# INFORMATION NOTE

N° 027/15

## BSS670S2L H6327 – Modification of die orientation

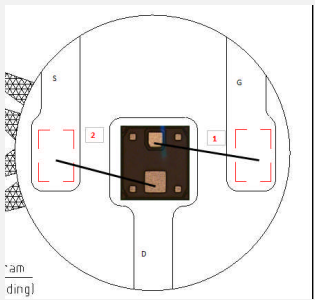
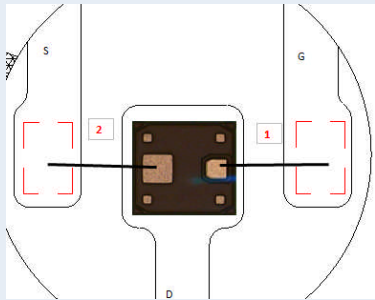
**Reason of Change:** Change of die rotation to standardize wire position with other products in PG-SOT23 packages

Description of Change:	<u>Old</u>	<u>New</u>
<b>Die rotation</b>	<p>Original die orientation</p> 	<p>90 degree rotated die</p>

**Assessment:** No influence on fit, form, function and reliability  
 Die bonding: no influence as the die size is square  
 Wire bonding: standardization of wire position
